ADDENDUM NO. 1

Date: **February 27, 2023**
Issued by: **Sacramento City Unified School District**
Project: **Project #0363-409 Theodore Judah ES Paving Repairs**

KEY PLAN	
➔	
SHEET TITLE: UTILITY PLAN	
JOB NUMBER:	SHEET NUMBER:
DATE: NOV 8, 2022	ADD1 C3.1
REVISION:

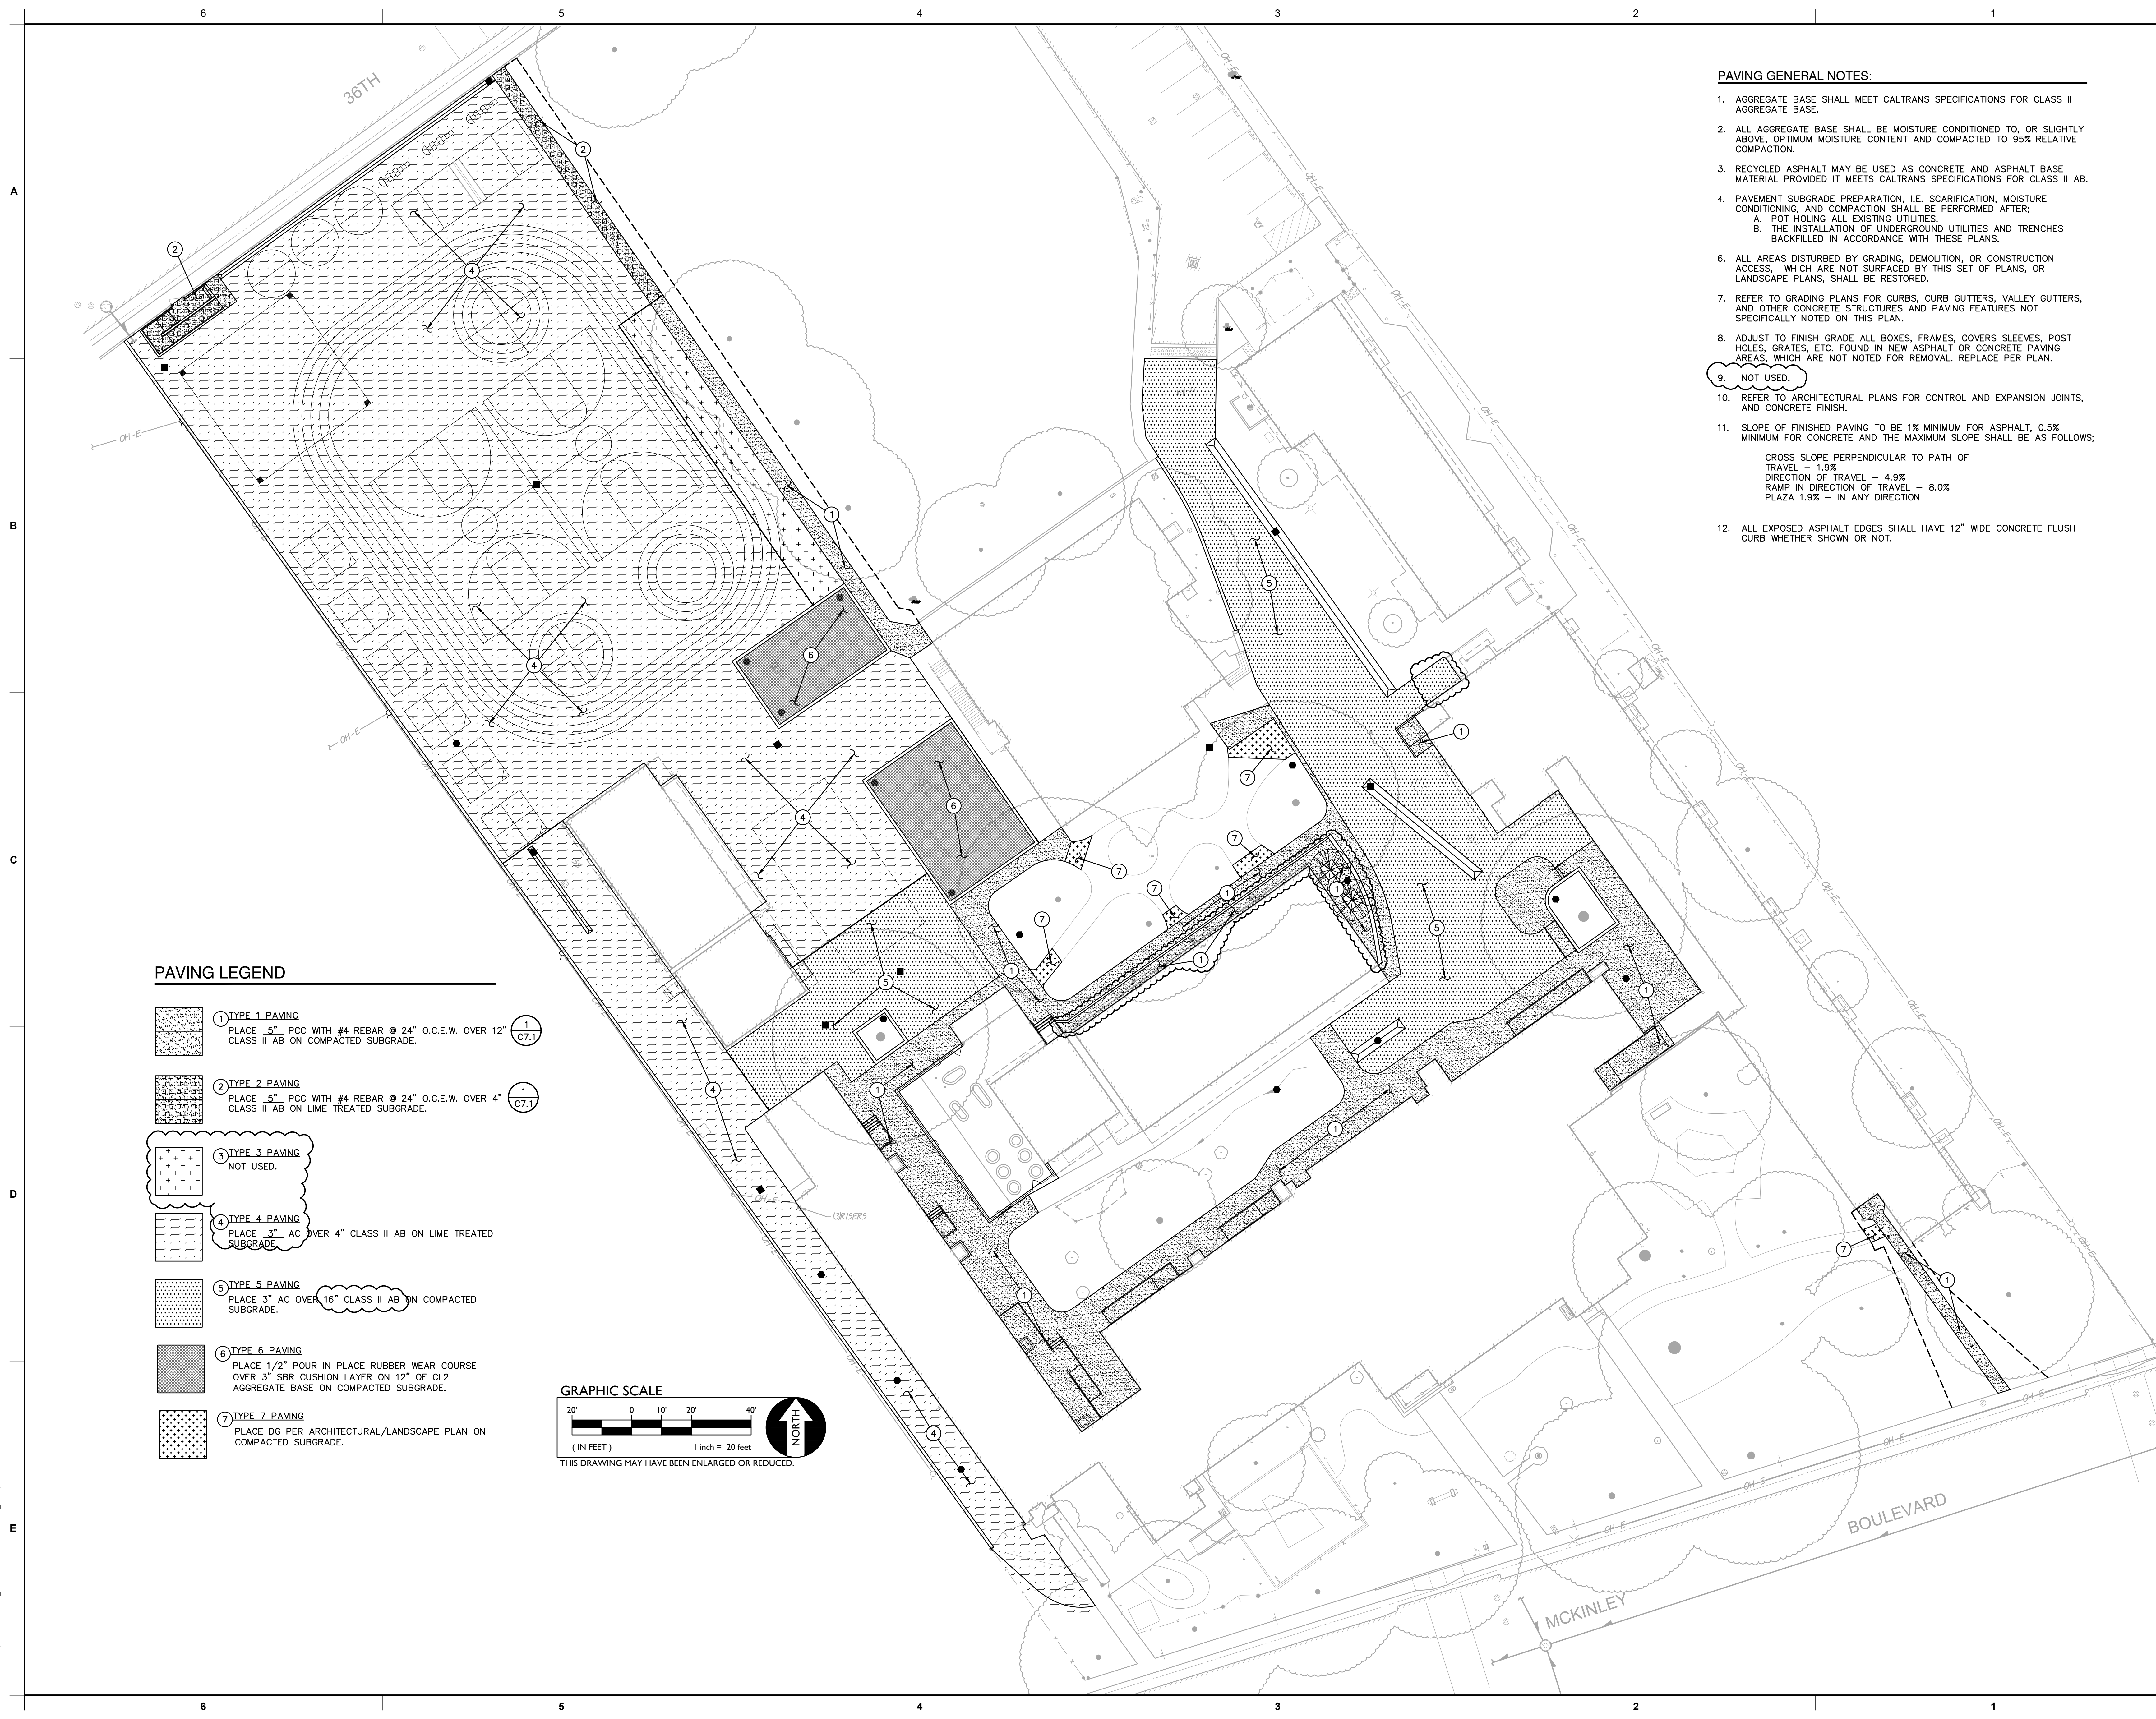
- AD01.12 Sheet C3.1 – Utility Plan: **Replace with the attached ADD1 C3.1.** Corrected mislabeled downspout note bubbles from 28 to 30. Added area drain and piping northwest of stage area. Extended area drain further into courtyard between buildings at south.

Q7: Sheet C3.1 Storm drain note #30 states to provide a downspout connection and to coordinate the exact locations with the architectural drawings. These connections appear to be missing on the utility drawing.

Q8: Sheet C3.1 Water note #61 states to match existing water pipe size. What size pipe should we figure for bidding purposes?

Q9: Sheet C3.1 Water note #63 states provide gate valve to match line size. What size gate valve should we figure for bidding purposes?

Q10: Sheet C3.1 Irrigation note #82 states irrigation pipe to match existing pipe size. What size irrigation pipe should we figure for bidding purposes?

Q11: Sheet C3.1 Gas note #91 states place gas pipe to match existing pipe size. What size pipe should we figure for bidding purposes?

Q12: Sheet C3.1 Gas note #93 states gas valve to match line size. What size valve should we figure for bidding purposes?

Q13: Sheet C3.1 It appears that there are a number of existing shallow electrical lines in the areas that will be lime treated. How should these lines be addressed?

Q17: Please identify the utility size for the gas and water lines on plan sheet C3.1. Contractor needs a baseline size for bidding purposes.

Q23: On plan sheet C3.1, notes 61, 81, and 91 all reference matching the existing pipe sizes. Please provide the existing pipe sizes.

A7: The down spout connections were misnumbered. They are correctly noted on the attached Sheet ADD1 C3.1.

A17: See response to Questions 8 through 12 above.

A23: The existing pipe sizes are unknown. See response to Questions 8 through 12 above for bidding.

JOB NUMBER:	SHEET NUMBER:
DATE: NOV 8, 2022	ADD1 C4.1
REVISION:

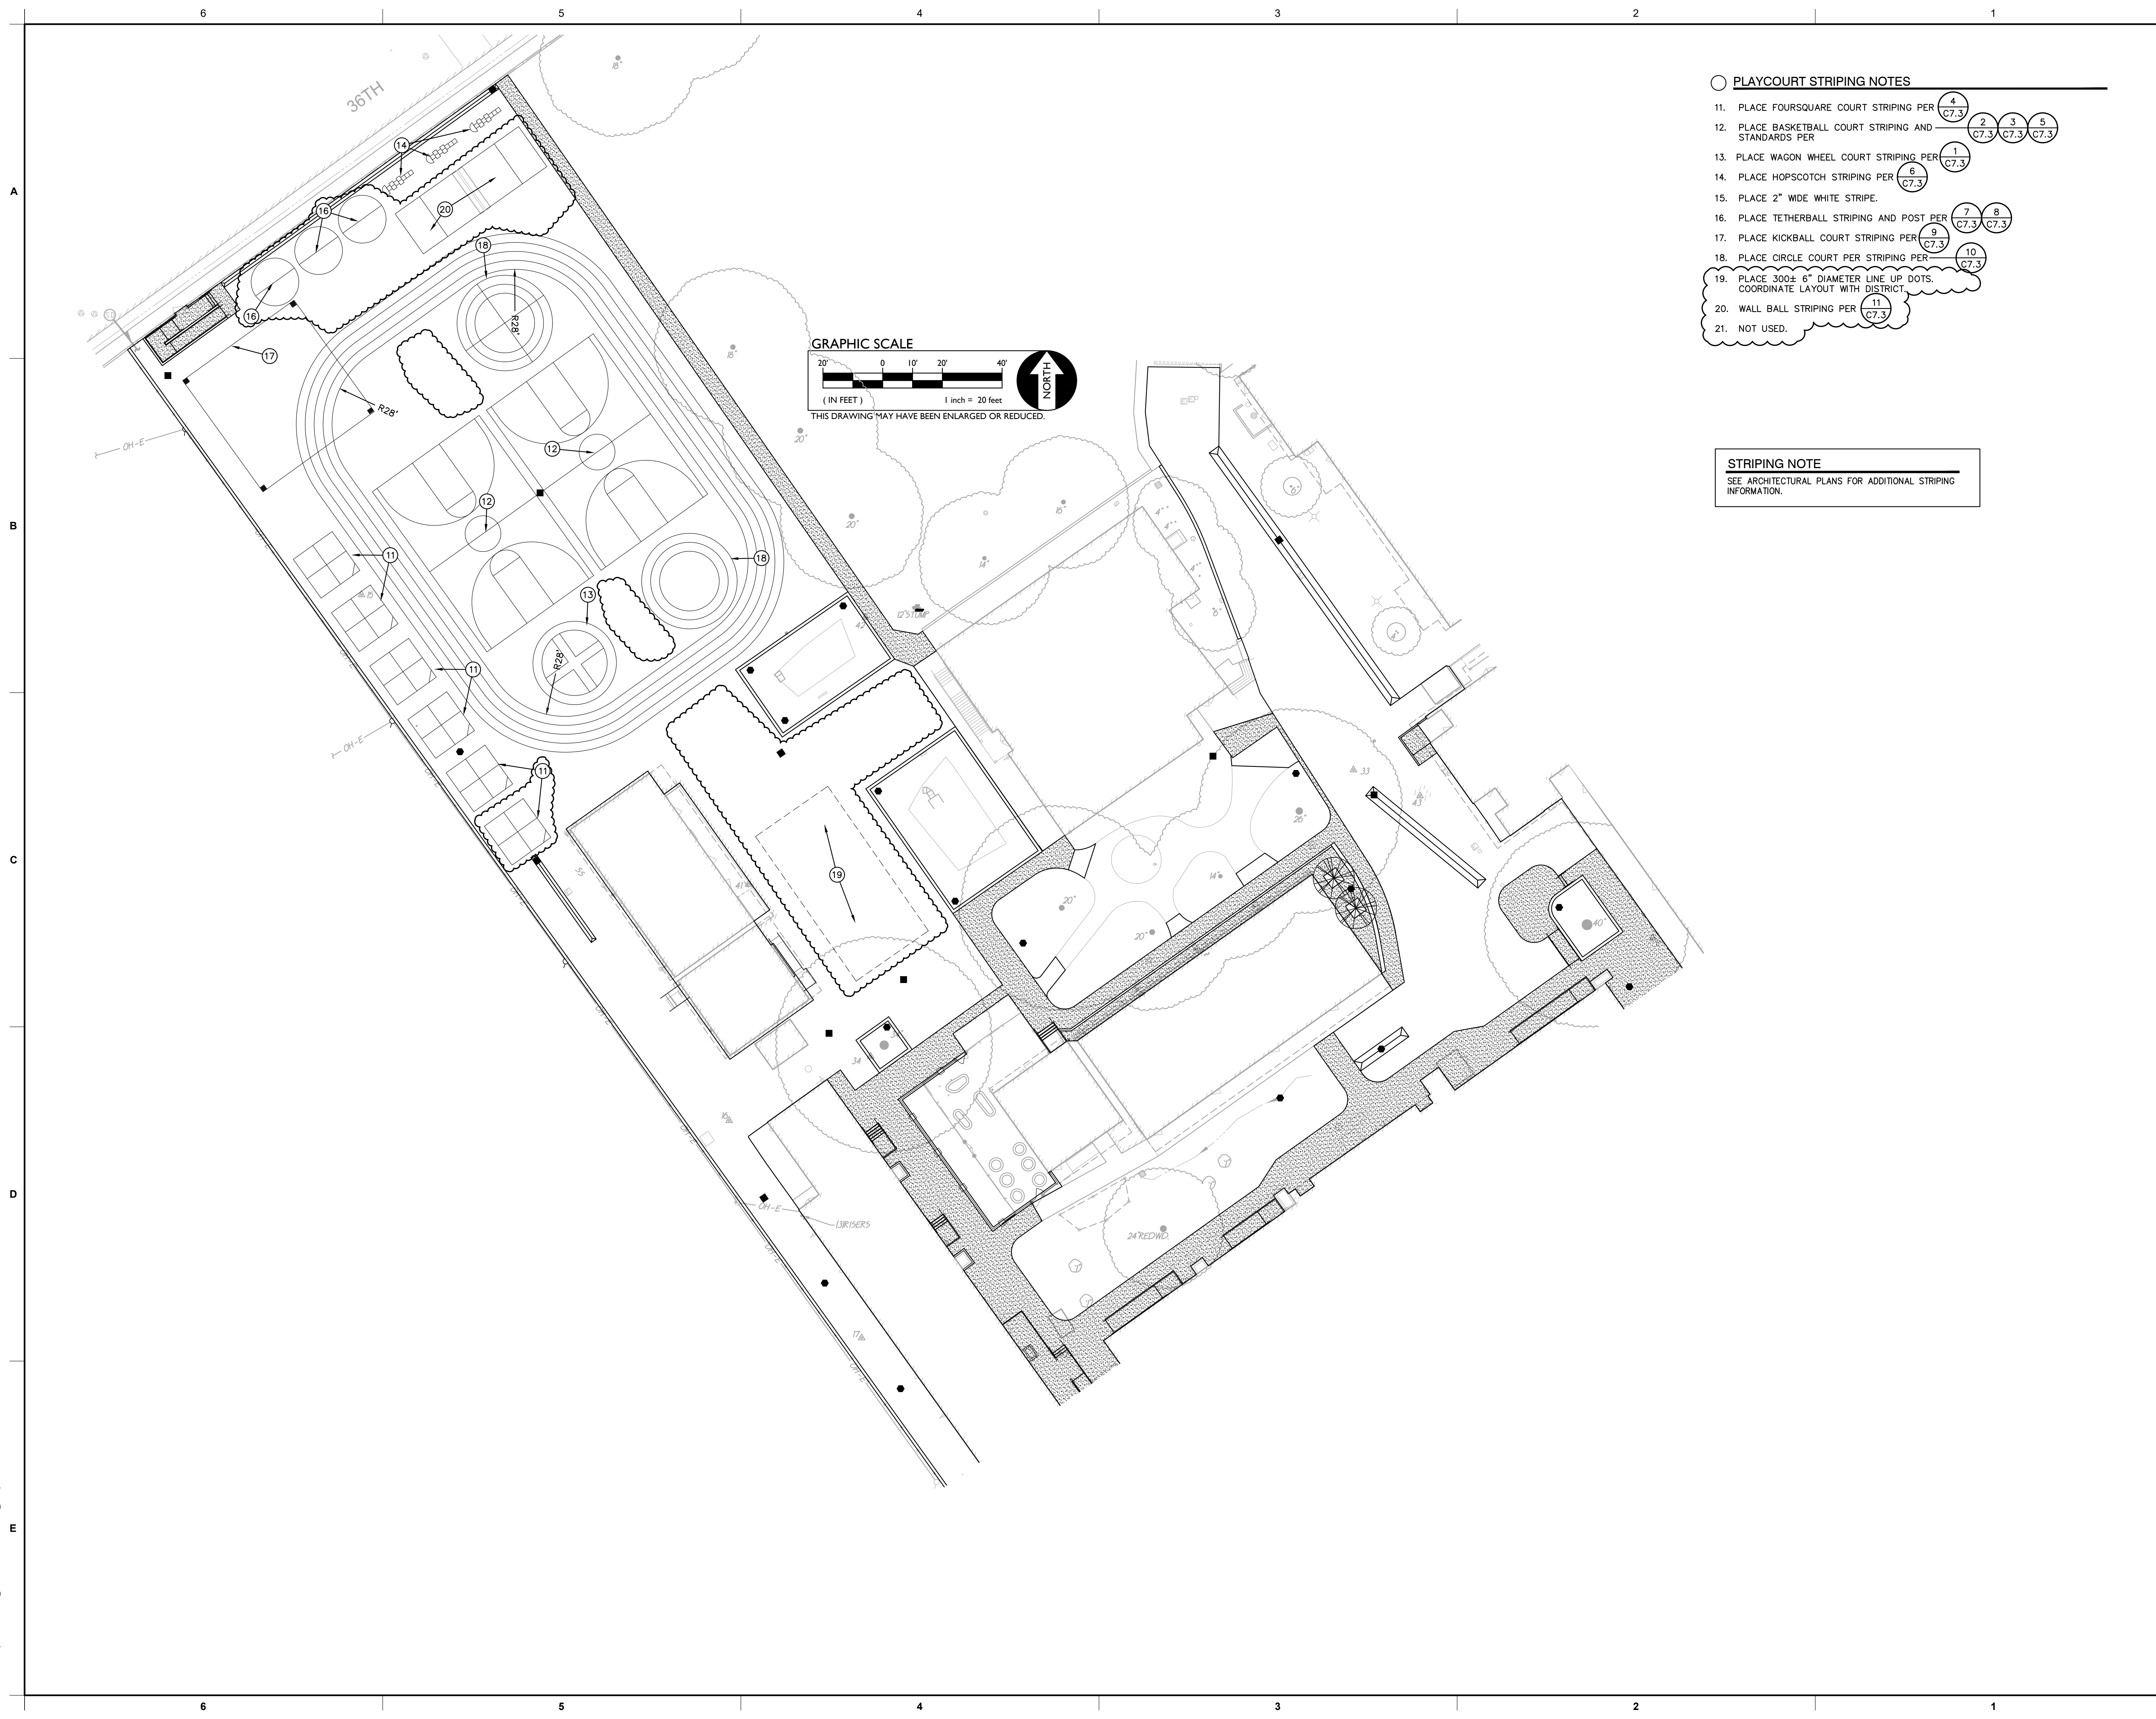
- AD01.13 Sheet C4.1 – Paving Plan: **Replace with the attached ADD1 C4.1.** Added additional flatwork around building west of stage. Updated the paving sections based on the soils report. Added paving near restroom building under shed that is being relocated.

Q1: Paving plan C4.1 – paving general note #9 states all new asphalt paving to be provided with seal coat per specifications. On previous projects the seal coat has been deleted due to the schedule. Will seal coat be required on this project?

A19: Additional paving call outs have been added around the building south of the trees and DG paths on the attached Sheet ADD1 C4.1.
